5. CONCLUSION

5.1 LANDSCAPE CHARACTER IMPACTS OF THE REVISED DESIGN

5.2 VISUAL IMPACT OF THE REVISED DESIGN

CO-1010

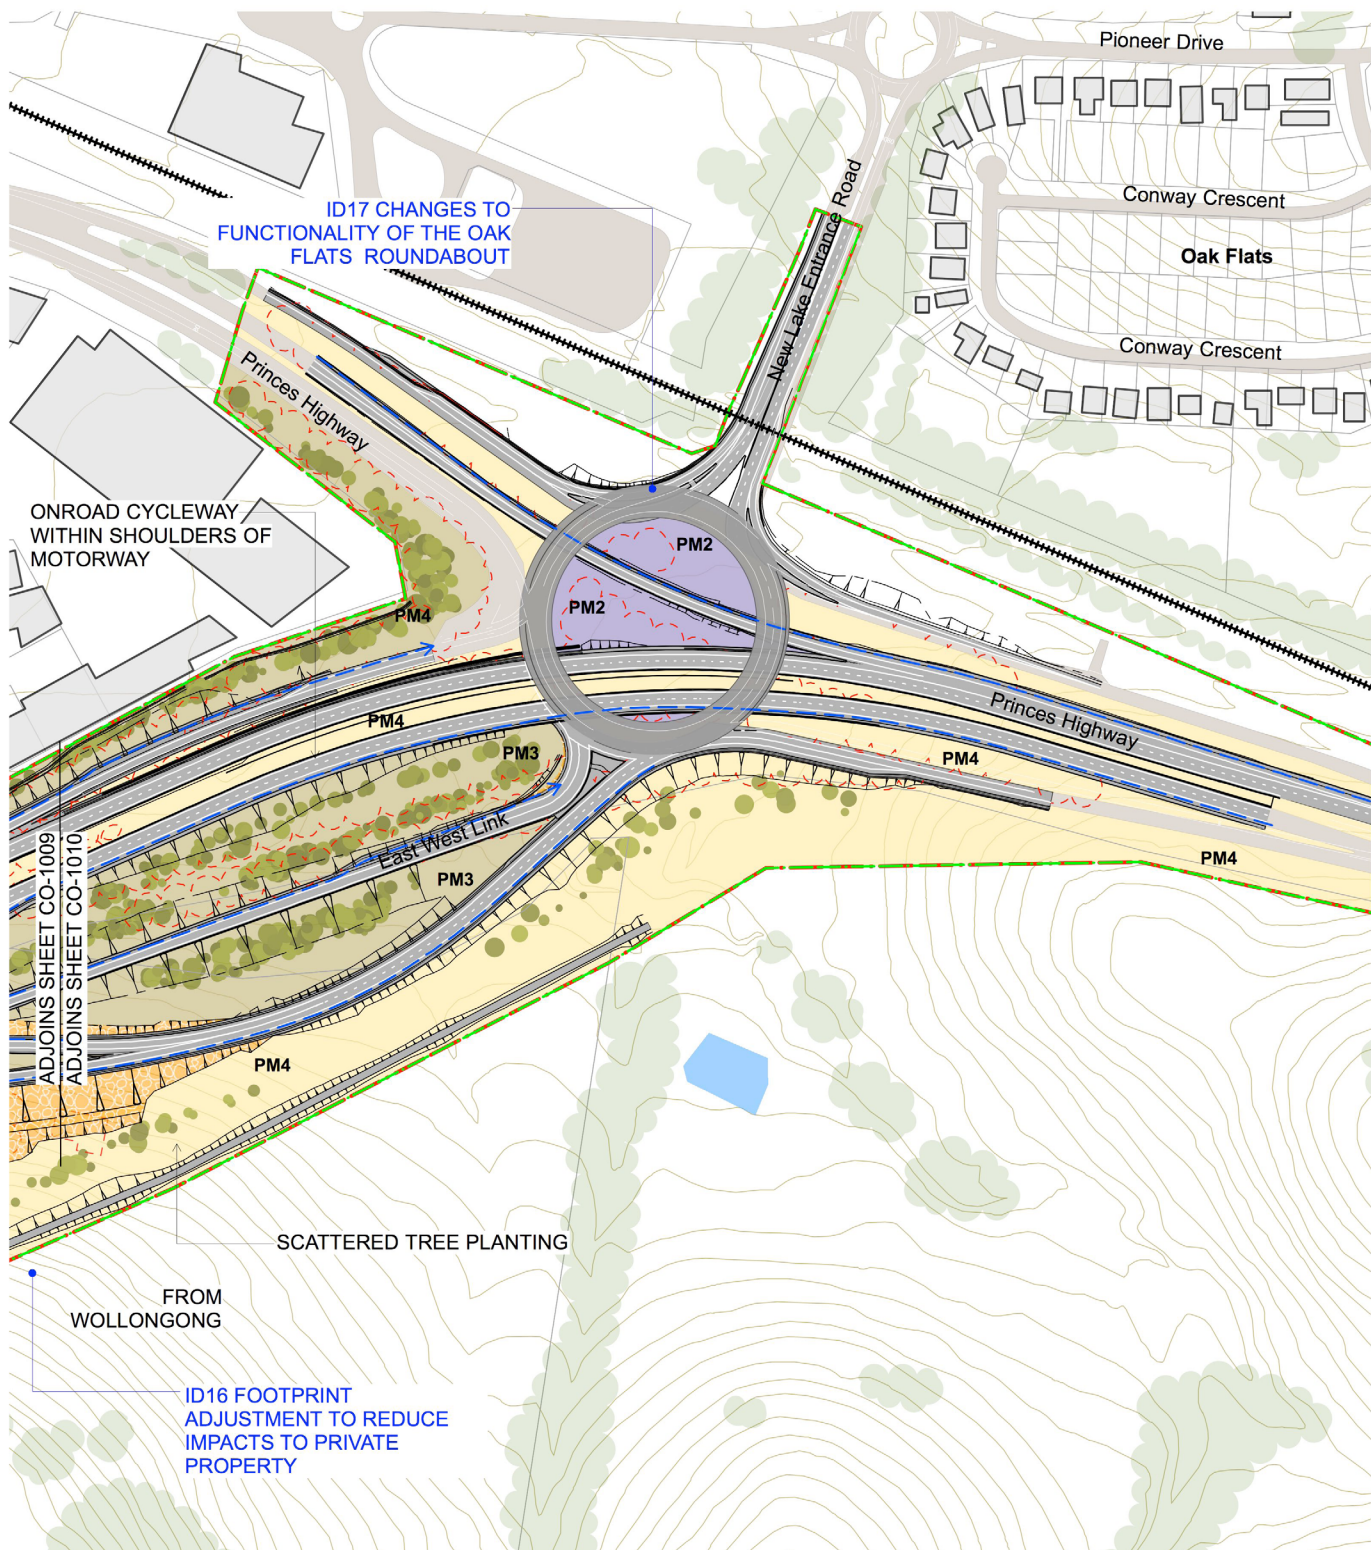
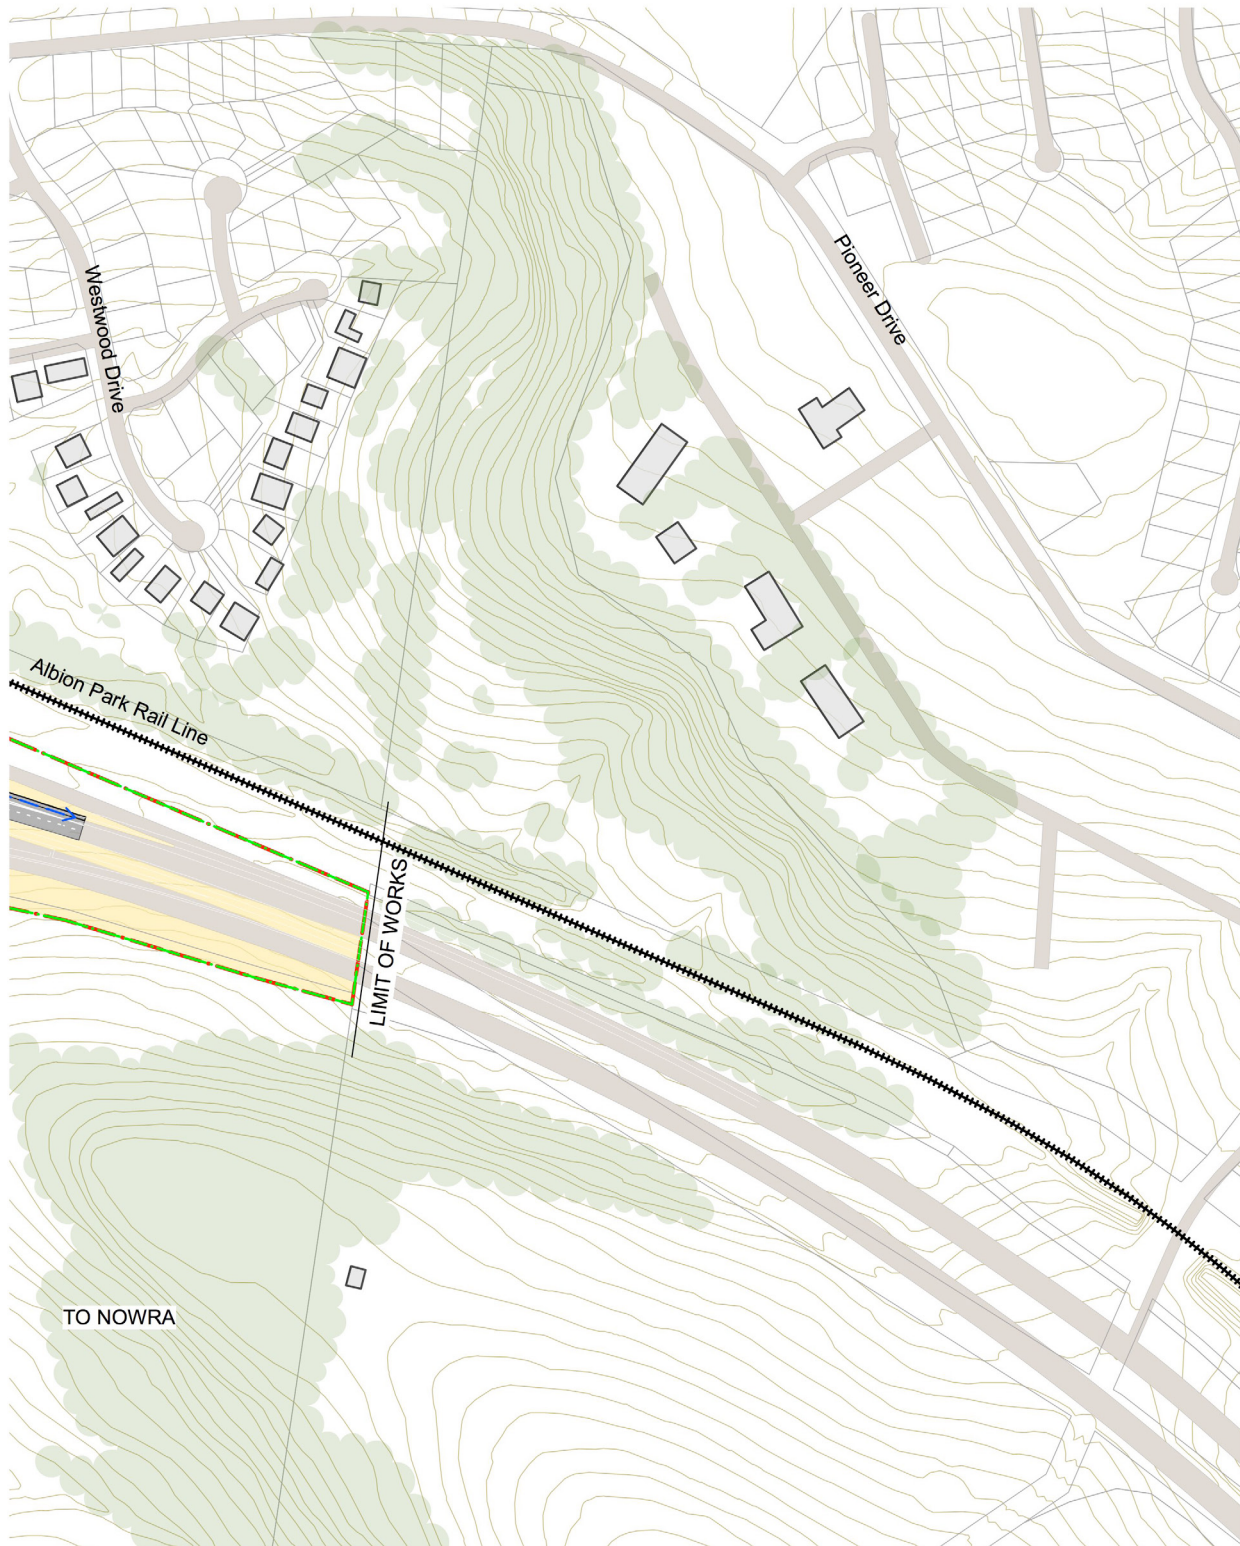
South of the Illawarra Regional Airport the likely visual impact on viewpoint 14 would be reduced relative to the EIS design due to modifications to the interchange that have relocated the northbound exit to south of Tongarra Road, reducing the magnitude of the proposed bypass in this view.

In southern Dapto two new viewpoints were introduced to assess the visual impact of the proposed changes to noise mitigation measures on motorists and residents. The proposed noise barriers under the revised design would be large built elements that were not anticipated in the EIS design. The assessment has found that there is an increase in visual impact as a result of the noise barriers. The revised design would result in a moderate-high visual impact for motorists along the Princes Motorway (new viewpoint 40) and a high visual impact for residents in southern Dapto (new viewpoint 41).

The need for operational phase noise management measures, including low noise pavement, noise barriers or architectural treatments, will be confirmed during detailed design. The chosen noise barrier design will be selected following investigations into engineering feasibility of the proposed mitigation measures and community consultation with residents from properties identified as exceeding, without mitigation, the Noise Criteria Guideline (Roads and Maritime, 2015) in the adjoining noise catchment area. The mitigation measures will be provided as early as practicable in the construction program to reduce potential noise impacts associated with construction.

Where noise barriers are found to be the preferred noise management strategy during future detailed design studies and consultation, the design of the barriers should seek to minimise the identified visual and amenity impacts, and be developed in accordance with the Roads and Maritime *Noise wall design guideline* to refine both the design and alignment of the barrier to maximise urban design and visual outcomes.
